Access Compliance Report Public Rights-of-Way (Curb Ramps)

Main Street: OAK RIDGE_DR Cross Street: KOOTENAY_DR Location: NW

ADA ID: RPAT211026093619 Ramp Type: Type 1 - Perpendicular Diagonal Initial Pass/Fail: Pass Overall Compliance: No Severity Score: 20

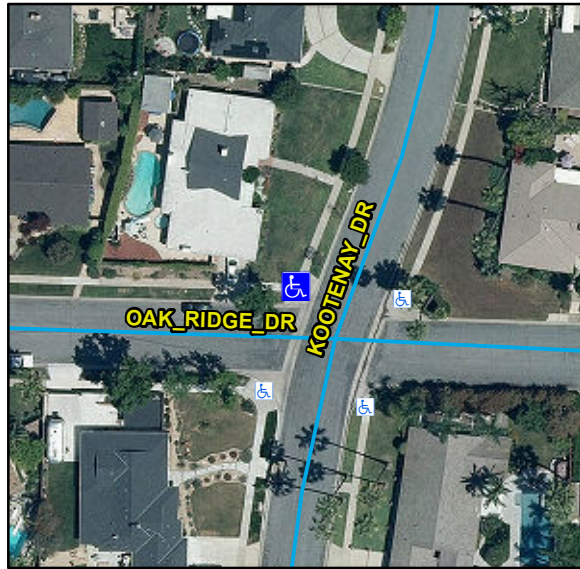
R304.2.2, R204.3, R304.2.1, R304.2.2-Perp, R304.3.2-Para, R304.5.3, R305, STD 1115

Remove & Replace Curb Ramp With Two New Directional Ramps or Equivalent.
